Expo Line Phase 2 Scoping Comments

Friends 4 Expo Transit
P.O. Box 64943, Los Angeles, CA 90064
www.friends4expo.org
April 2, 2007

- **Overland Ave. underpass**

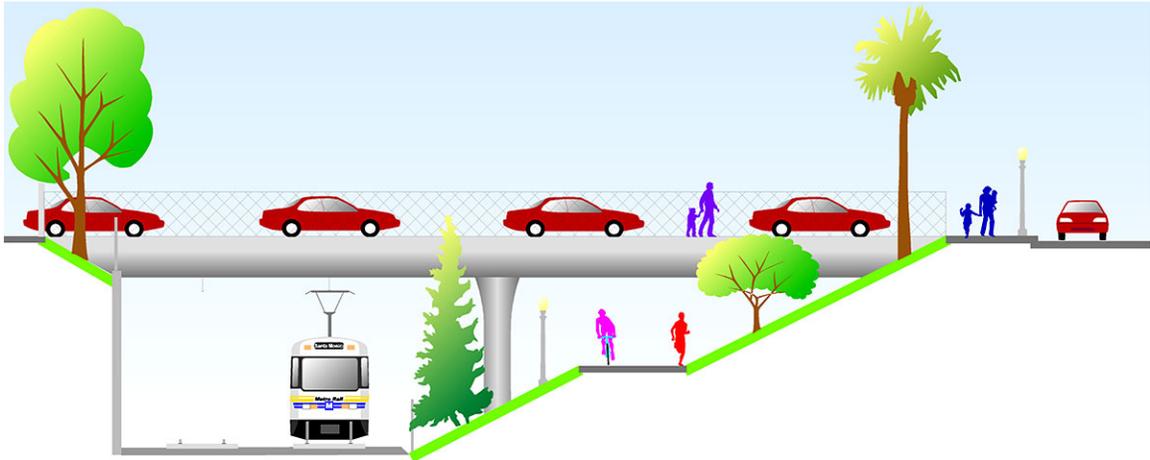
Traffic volumes on Overland Avenue appear to exceed the criteria for specifying a **grade separation** in the 2003 *MTA Grade Crossing Policy*. A local EIR counted a 2005 PM peak on Overland southbound below Pico of 2,617 (1,309 per lane), which exceeds the upper Threshold 3 into “Grade separation usually required”.

Overland Avenue Elementary School (right in photo) borders Overland and Northvale Avenues (as Charnock Road Elementary School borders Sepulveda Boulevard). Planning for **student safety** is crucial at all school locations.

These **power lines** along Overland would need to be relocated for an aerial grade separation. They are also a counterpoint to objections about light rail overhead catenary wires.

It has long been a compelling idea to **extend the existing trench** to an **Overland light rail and bike path underpass**, as in this sketch:

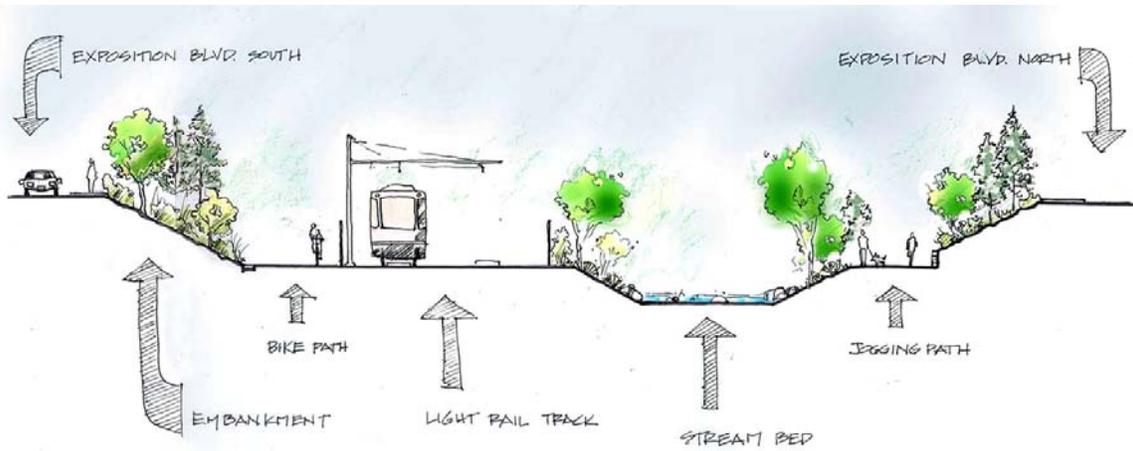
There is, however, the complication of a large concrete box **storm drain** running under Overland. Its outside dimensions are 11'-9" high x 12'-8" wide, with its top about 5 feet below the old rail tops¹. An 18" main sewer parallels it about 4 feet deeper.

A new **inverted siphon** section is a possibility for carrying storm flows below depressed light rail tracks under Overland.

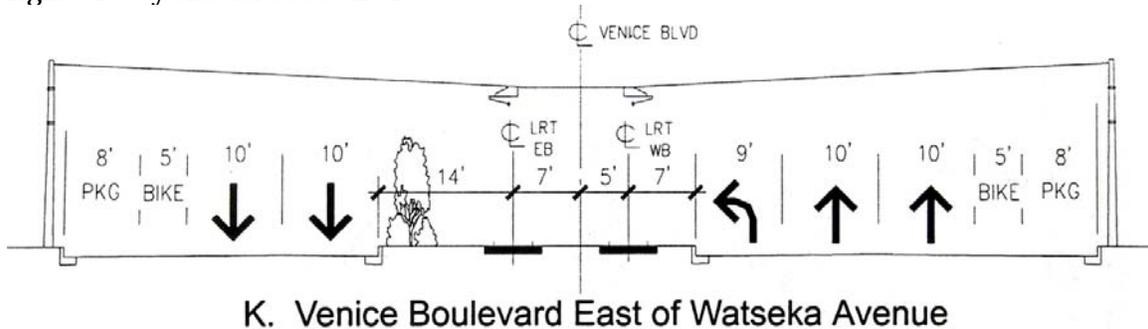
- **Loss of traffic lanes and other impacts on Venice Blvd.**

Venice Boulevard between Robertson and Culver Boulevards (shown here looking west) is very congested, with three lanes in each direction and double left turn lanes.

An **aerial alignment** from the Culver City station to west of the historic Ivy Substation may be needed here, although even space for columns would be difficult.

The Venice Blvd. section drawing (below) from the 2001 *Draft EIS/EIR* (Figure 2D-7) shows **loss of one traffic lane** in each direction. Additional impacts to **cross traffic**, **parking**, and **adjacent businesses** that appear to be using former Venice Boulevard right-of-way should be studied.

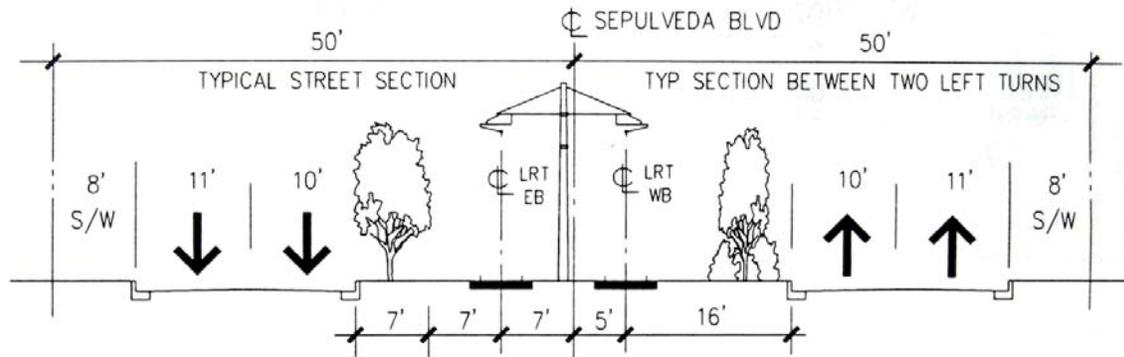
The intersection of Venice and Sepulveda Boulevards is very congested at peak periods, and would likely delay trains waiting for their turn signal phase.

Travel time estimates based on the current Blue Line schedule suggest this route may be as much as **10 minutes – 25% – slower** due to its one-mile-longer length, 35 mph vs. 55 mph top speed, and intersection delays.

An **aerial curve** here is a possible mitigation (and could transition into the **hill** visible on Sepulveda, eliminating that steep grade). If considered, it should be planned **not to preclude a future extension** farther west on Venice Boulevard.

P. Olympic Boulevard West of 20th Street

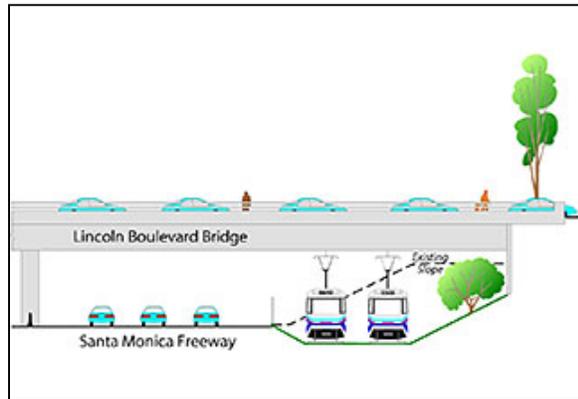
The **grass and coral tree median** of Olympic Blvd. in Santa Monica west of 20th Street is a local landmark. The 2001 *Draft EIS/EIR* (Figure 2D-10) suggested the tracks be next to the median and would preserve the trees (above). Safety, speed, and less traffic here **support a dedicated track lane**, not the 2001 **mixed flow** proposal.
